Technical Newsletter

June.2024 Service Operation Team

Integrated front glass material for IR PTZ cameras

- **Model** : High Performance X-Series PTZ Cameras XNP-xx00RW/Cxx03RW

[No ink on IR area]

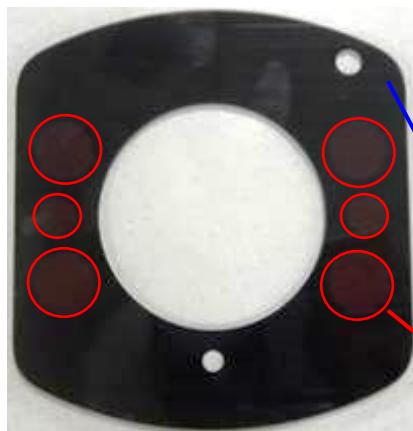
- **Original materials by model**

- 1) XNP-XX00RW (X-Plus)

- . Material code : FC37-001073B
- . Front glass feature: No ink on IR area

- **Integrated material for front glass_ X-Plus & X-Plus AI PTZ** (From Apr. 2023)

- Material code: FC37-001103A
- Front glass feature: Black ink + IR ink on IR area
- Advantages of using integrated materials
 - . Ensure design uniformity and improve appearance through the use of compatible materials
 - . Black ink is strongly resistant to IR light which enhances reliability
 - . IR ink improves light transmittance in the IR area while keeping aesthetic unity
